Groundwater Review Summary Form

Application # G- 18369

PUBLIC INTEREST REVIEW FOR GROUNDWATER APPLICATIONS

A. GENERAL INFORMATION: Applicant's Name: TSW Nursery Sales County: Marion

Water-Level Trends in Nearby Wells

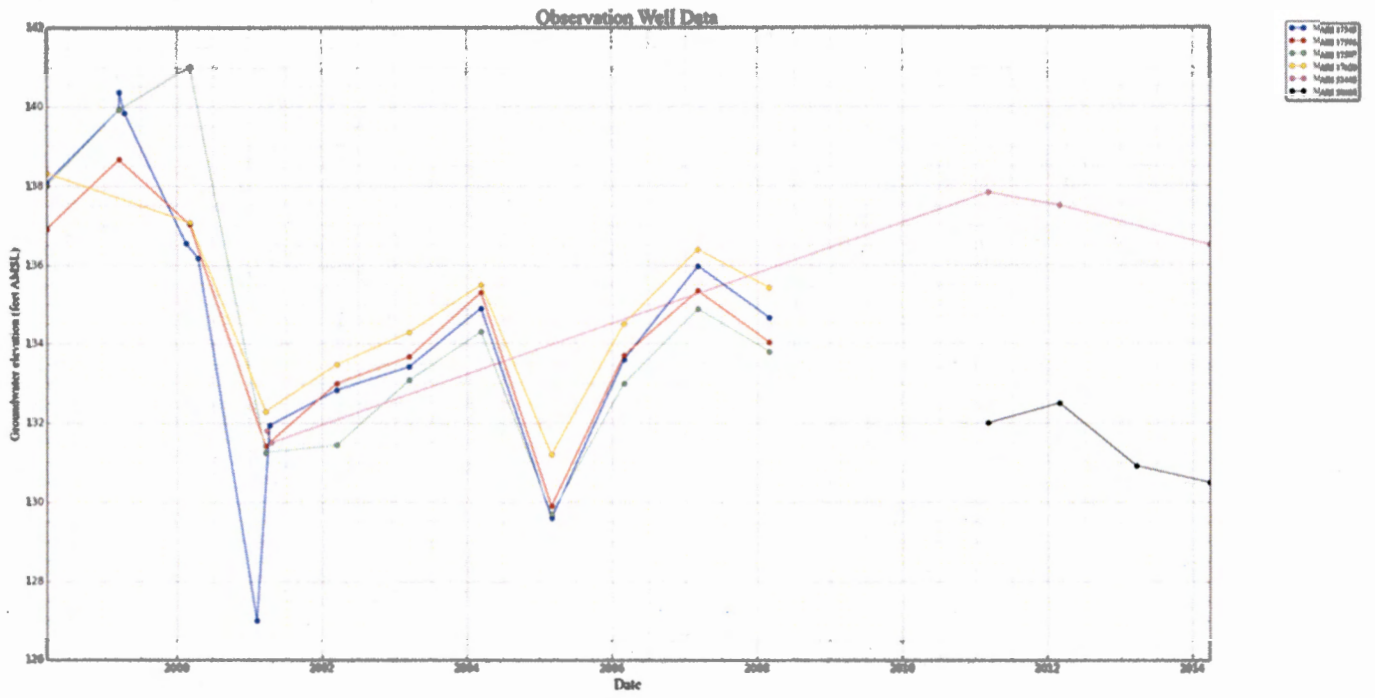
Water level data available from nearby alluvial wells show fairly stable trends over the past 15-20 years. However, in some nearby wells seasonal groundwater levels have fluctuated by as much as 25-30 feet (see hydrograph). Furthermore, the productive sand and gravel deposits are relatively thin, and well interference is likely to extend over broad areas due to the confined aquifer conditions (low storativity). Consequently, seasonal pumping interference between area wells is possible.

G-18369 TSW Nursery Sales - Well 1/SW 1

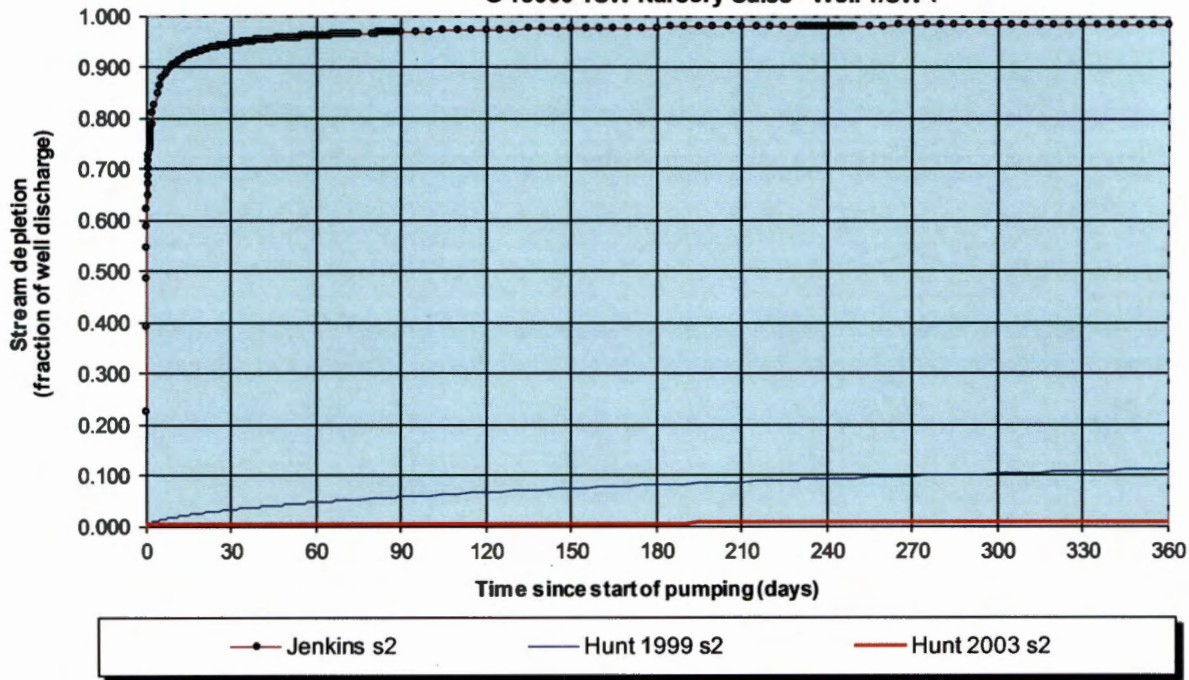
C3a: Potential depletion of SW1 (Deer Creek) by both Well 1 and Well 2 was estimated using the Hunt 2003 analytical stream depletion model (Hunt, 2003). Because distributed well discharge (Qw) was not specified in the application, both wells were simulated to pump the total Qw (0.335 cfs) for an entire year; two models were developed to simulate pumping of only one of the wells at a time. Aquifer parameters used for the models are typical of those reported for this hydrogeologic regime (Conlon and others, 2003, 2005; Iverson, 2002; Woodward and others, 1998); published parameter values were substantiated by derived results from nearby pumping tests (primarily from MARI 53448, which is nearest to the two well locations and similarly completed).

The Hunt 2003 analytical modeling results for both Well1/SW1 and Well 2/SW1 scenarios indicate that stream depletion is expected to be much less than 25% after 30 days of continuous pumping.
